**DOE-ID NEPA CX DETERMINATION
Idaho National Laboratory**

SECTION A. Project Title: Sample Preparation Laboratory Rev 2

SECTION B. Project Description and Purpose:

Figure R1. SPL project location and construction activities.

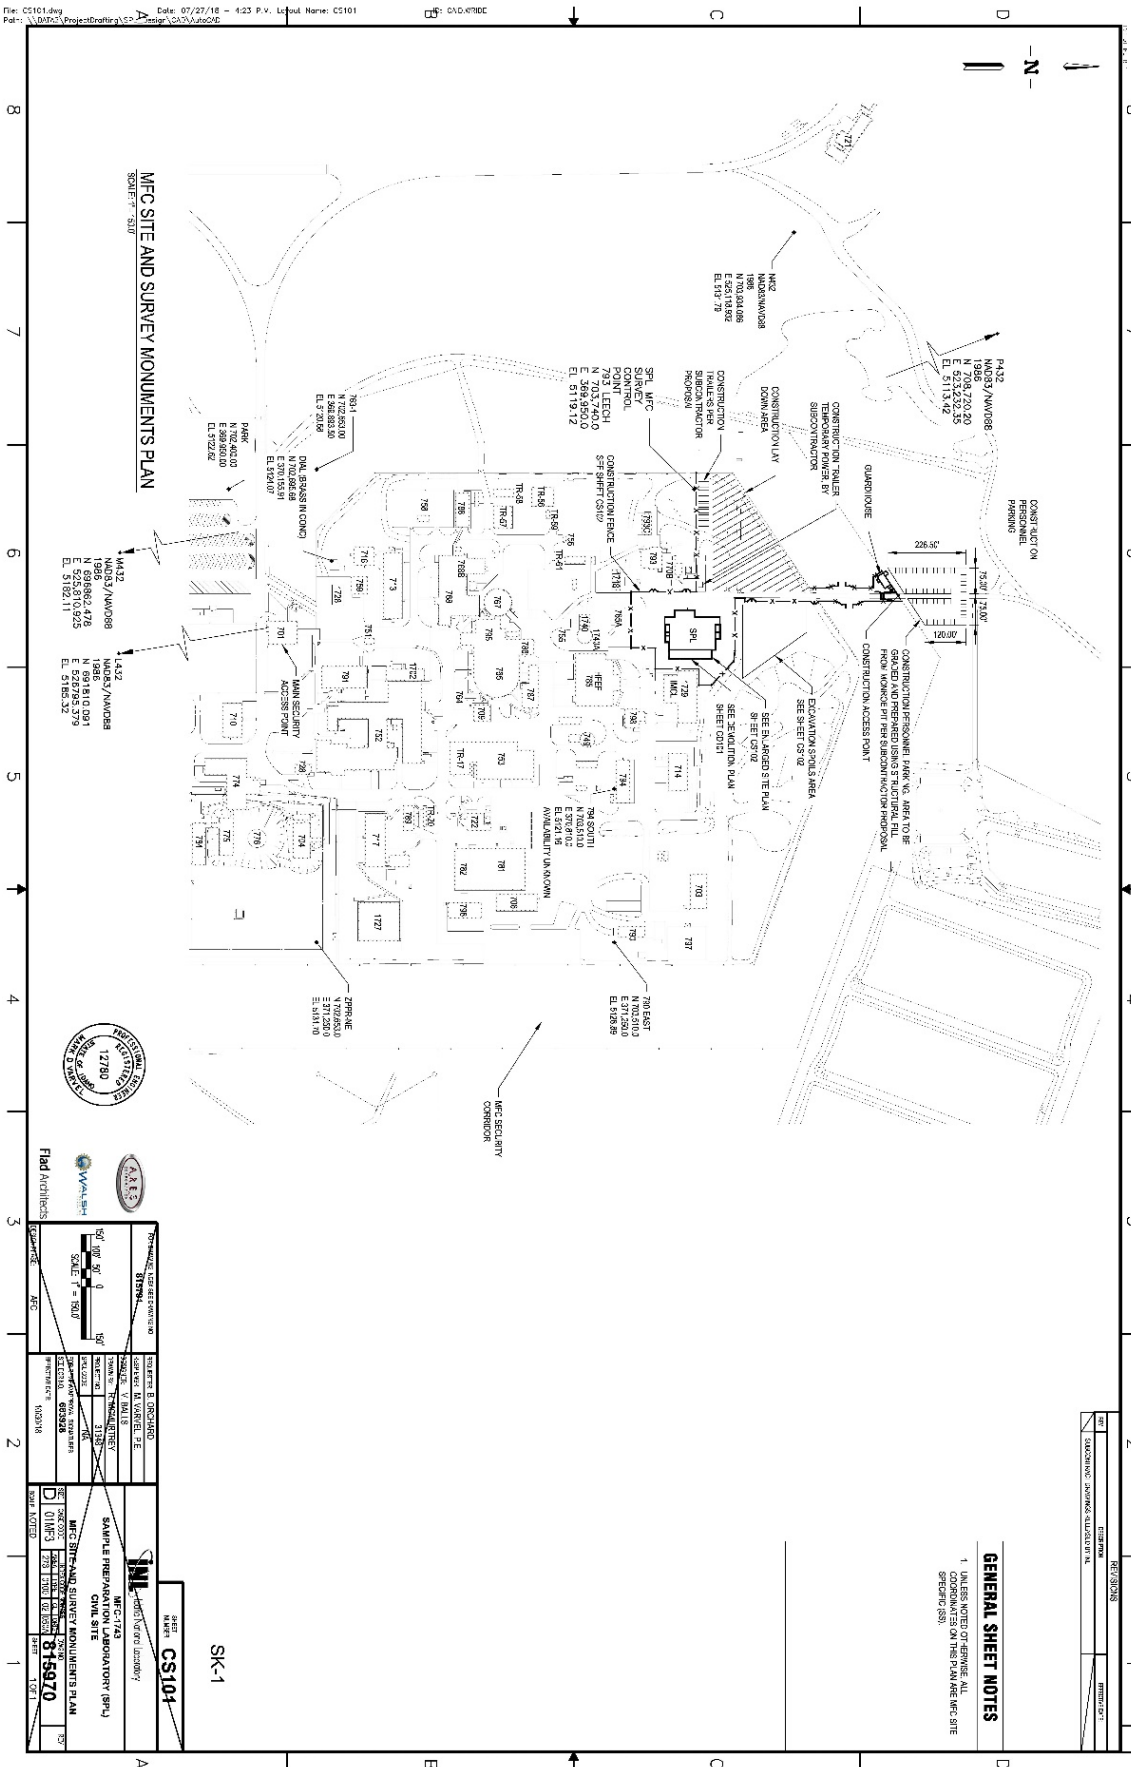
This environmental checklist (EC) is being revised to address changes in the scope of construction of the Sample Preparation Laboratory (SPL) at the Materials and Fuels Complex (MFC) at Idaho National Laboratory (INL). This revision makes the following changes to the original scope:

- Increases size of the SPL from 44,000 to 49,000 ft²
- Changes from a masonry block structure to a steel structure with architectural pre-cast walls
- Removes requirements of Executive Order 13693
- Removes the requirement for the building to be Leadership in Energy and Environmental Design (LEED) “Gold” certified
- Constructs a 26,000 ft² gravel parking lot
- Installs a new security check point trailer, fencing, and pop-up security barrier between or immediately outside the existing security fences
- Supplies temporary power from facility power to the new security check point trailer, construction support trailers, and the SPL construction site.

Figure R1 shows the location and proposed construction activities.
